UNITED NUCLEAR
CORPORATION
CHEMICALS DIVISION
FEBRUARY 24, 1964

SUBJECT: SNM-33 AMENDMENT TO INCLUDE SHIPPING CONTAINER BE-1351

BE PERMIT 1351

SK-5 REVISED 2/24/64

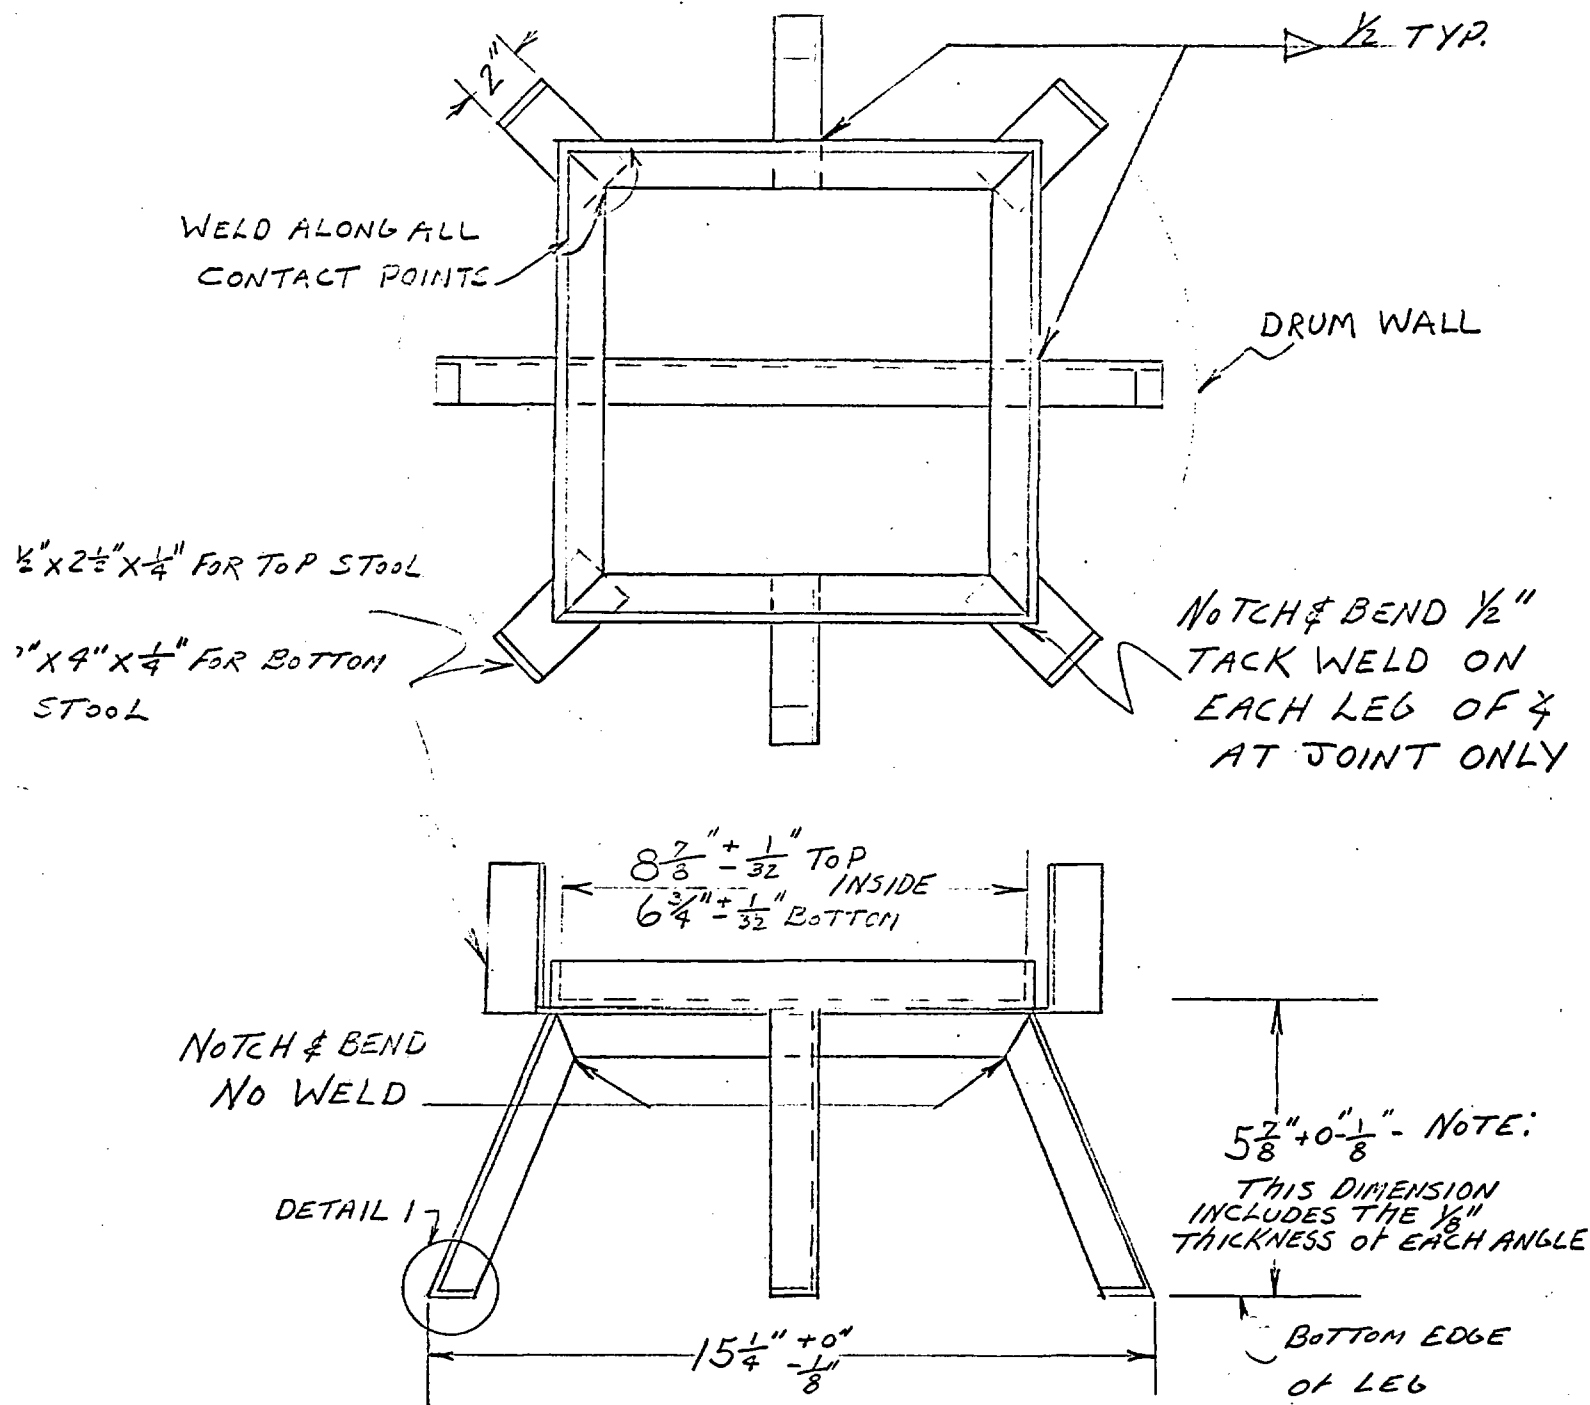
REPLACE SK-5 WITH SK-5, REVISED FEBRUARY 24, 1964

THE ASSEMBLED ARRANGEMENT OF THE CONTAINER IS SHOWN ON SKETCH SK-5 REVISED 2/24 WITH DETAILS OF THE SUPPORTING STOOLS AND INNER POT OR CONTAINER SHOWN ON SKETCHES SK-23 AND SK-23-1, REVISED FEBRUARY 24, 1964.

THE INTERNAL CONSTRUCTION OF THE CONTAINER IS SHOWN ON DRAWING SK-5 REVISED FEBRUARY 24, 1964 AND SK-23-1 REVISED FEBRUARY 24, 1964. THE 15 GALLON DRUM IS A STANDARD ICC TYPE 37-A-350 DRUM FABRICATED FROM 20 GAUGE STEEL. THIS DRUM WAS DROP TESTED FROM A HEIGHT OF 30 FEET. A DROP ON THE END RESULTED IN LESS THAN A FIVE PERCENT CHANGE IN THE SPACING BETWEEN THE BOTTOM OF THE DRUM AND BOTTOM OF THE "POT". A DROP ON THE SIDE RESULTED IN A MAXIMUM REDUCTION OF $1\frac{1}{4}$ " ON THE DIAMETER OF THE DRUM (CORRESPONDING TO A MAXIMUM REDUCTION OF $1\frac{1}{4}$ " IN THE SPACING BETWEEN THE DRUM AND POT ON THE SIDE OF THE IMPACT). THE MINIMUM DRUM DIAMETER IS THEREFORE $14\frac{3}{4}$ ". THE NET VOLUME OF THE DRUM AFTER THE DROP IS THEREFORE 1.7 CUBIC FEET. FROM FIGURE 23 OF TID-7016, REVISION 1, AT LEAST 20 SUCH UNITS IS A SAFE QUANTITY.
